17 May 2018

**Re: Shenkman/Cavanagh – Kanata West
195 Huntmar Community Transportation Study – Addendum #1**

Section 2 of this addendum addresses the comments received from the City of Ottawa, dated November 24, 2016 in order to complete the file.

Figure 2: Original Palladium Drive Extension Alignment

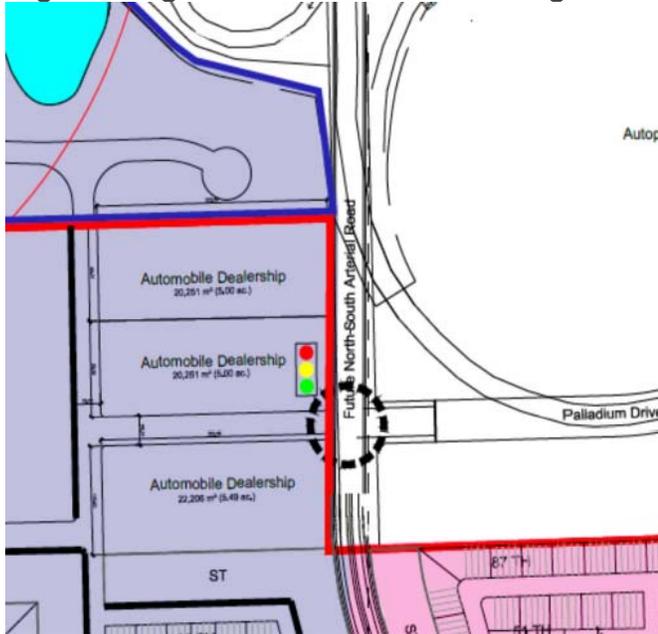
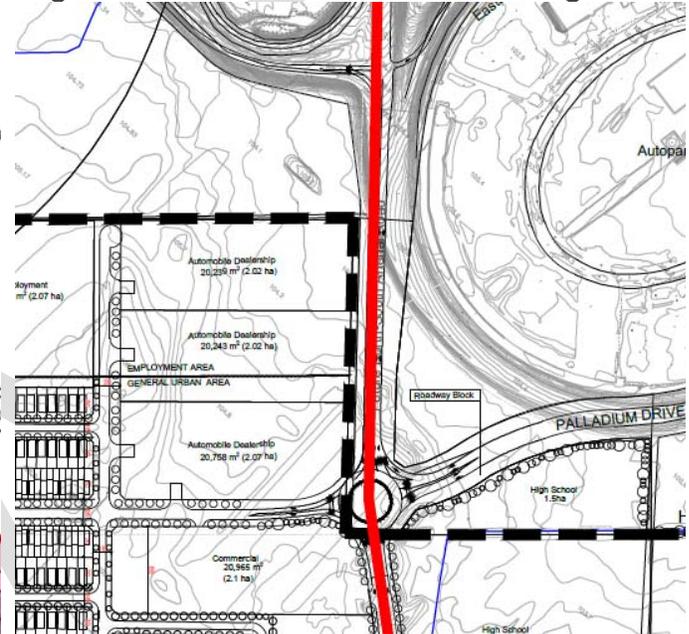
Within the original CTS, the location of the Palladium Drive extension to the North-South Arterial was proposed approximately 350m north of the planned North-South Arterial/Stittsville Main roundabout intersection and approximately 300m south of the HWY 417 eastbound off-ramp. Through consultation with the Ministry of Transportation of Ontario (MTO), we were advised that the location of the proposed Palladium Drive extension to North-South Arterial is too close to the HWY 417 eastbound off-ramp. Through further consultation with the project team, the City, and adjacent land owners, a revised location of the proposed Palladium Drive extension to North-South Arterial is proposed. The revised location is approximately 400 m south of the HWY 417 off-ramp and approximately 250 m north of the North-South Arterial/Stittsville Main intersection. The original proposed location and the revised location are shown as Figures 2 and 3, respectively.

The following revisions to the Palladium Drive Extension and North-South Arterial intersection are presented:

- The revised Palladium/N-S Arterial intersection is proposed to be a multi-lane roundabout;
- The intersection is located approximately 400 m south of the HWY 417 eastbound off ramp;
- The intersection is located approximately 250 m north of the proposed N-A Arterial/Stittsville Main intersection;
- To accommodate this alignment, the land south of the Palladium Drive extension has been acquired by the proponent and will be incorporated into the proposed development as part of the high school lands;
- This revised alignment improves east-west connectivity to the site by aligning Palladium Drive with the east-west collector roadway that continues through the site to Stittsville Main Street extension.

Figure 6: Proposed Road Alignment

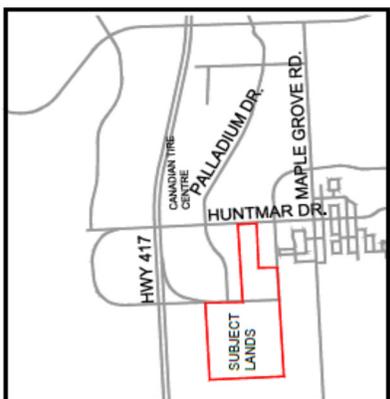
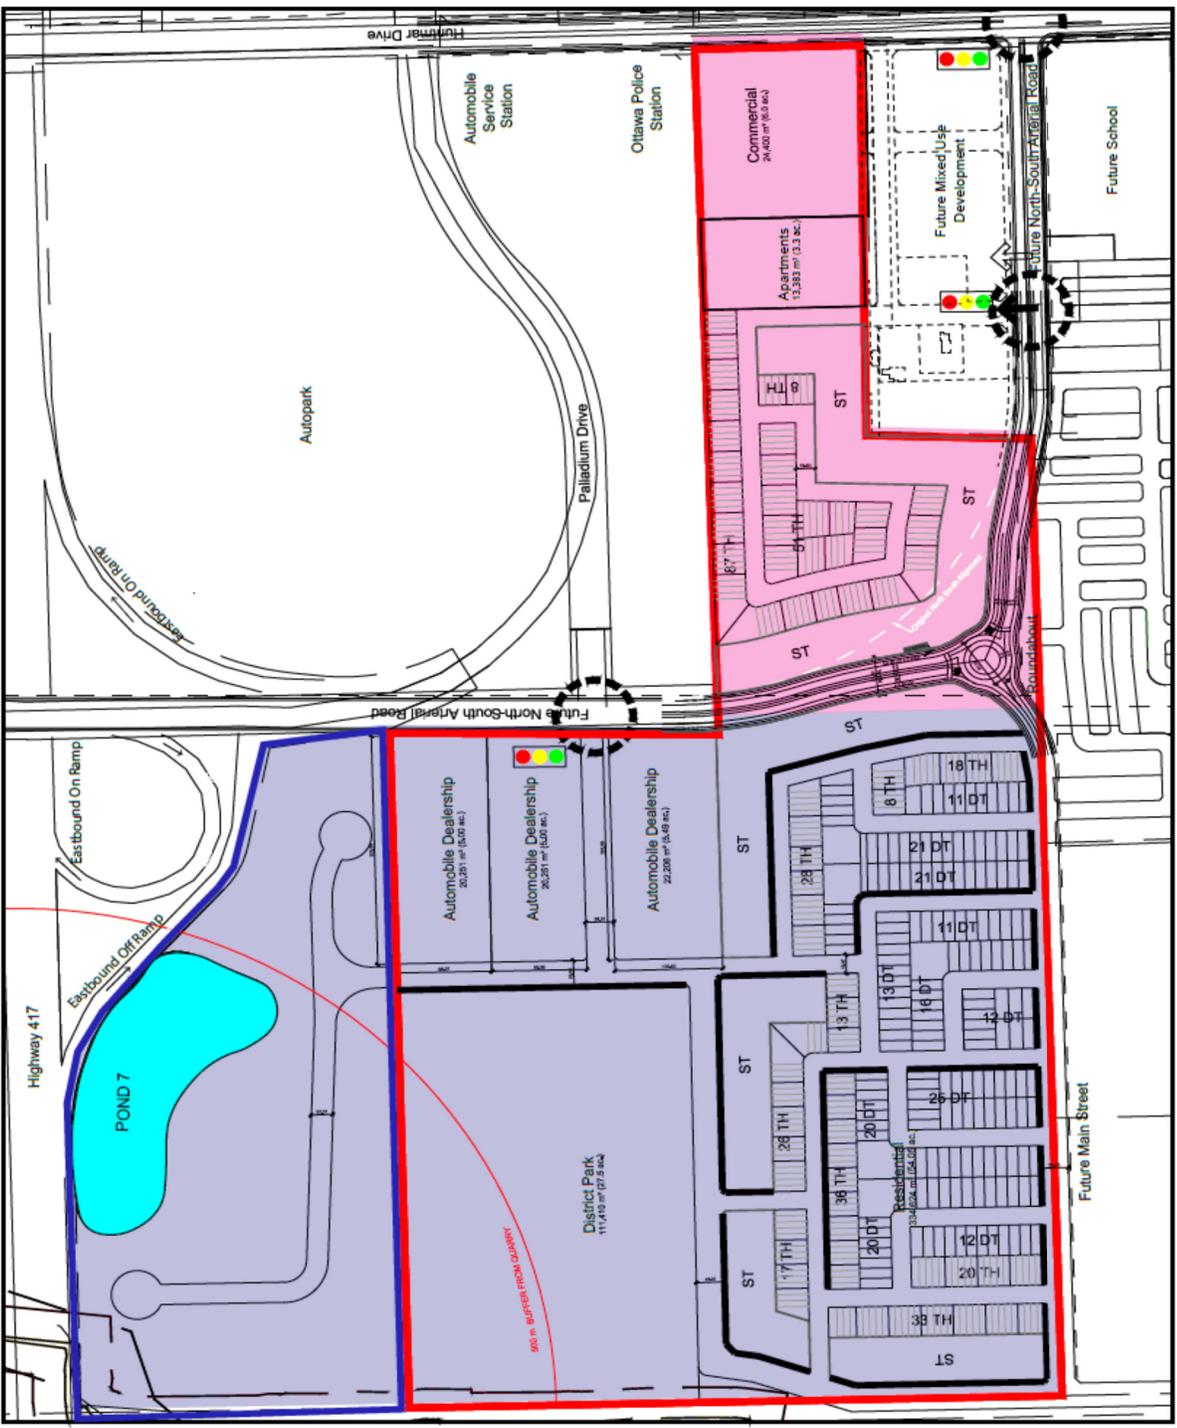
Comment 1: *Please expand on the potential ROW conflict between the extension of Stittsville Main Street north of the N-S Arterial to Palladium Drive. This argument is used to exclude a portion of the future Stittsville Main Street extension, yet details of this statement are not presented.*

Response 1: The Kanata West Concept Plan shows the extension of Stittsville Main Street continuing past the North South Arterial, intersecting with Huntmar Drive and continuing east to intersect with Palladium Drive at Cyclone Taylor Boulevard. During the EA process for the West Transitway Extension, to accommodate the geometry of the transit alignment, the segment between Huntmar Drive and Cyclone Taylor Boulevard was removed, and it was deemed to be redundant to the network. By extension and given the lack of connectivity of Stittsville Main Street extension through Huntmar Drive, the segment between the North South Arterial and Huntmar Drive ends at a three-legged intersection at Huntmar Drive and provides little to no gain in terms of vehicle capacity, given the capacity along Huntmar. Huntmar is not planned for any reconstruction until post 2031.

As described in section 1 of the addendum, the land use patterns and resulting transportation network has been modified within the Concept Plan to provide more of a grid pattern. This effort follows the goals of the Building Better Smarter Suburbs direction from the City. While the geometry of the major roadways differs from older plans, the use of proposed roundabouts has enabled the formation of a grid.

The resulting roadway pattern continues to provide similar connectivity as the older Kanata West transportation plan. From the point where the Stittsville Main Street extension reaches this development, it splits into two paths, namely Streets 14 and 1 & 3. These collectors then intersect the North South Arterial at the two proposed roundabouts, which both continue east to provide connectivity to Huntmar Drive via the North-South Arterial and the Palladium Drive extension. As such, east-west capacity that would have been accommodated by the extension of Stittsville Main Street extension to Palladium Drive is accommodate via the two proposed collectors (Streets 1 & 3 and 14) and their revised intersections with the Palladium Drive extension and the N-S Arterial.
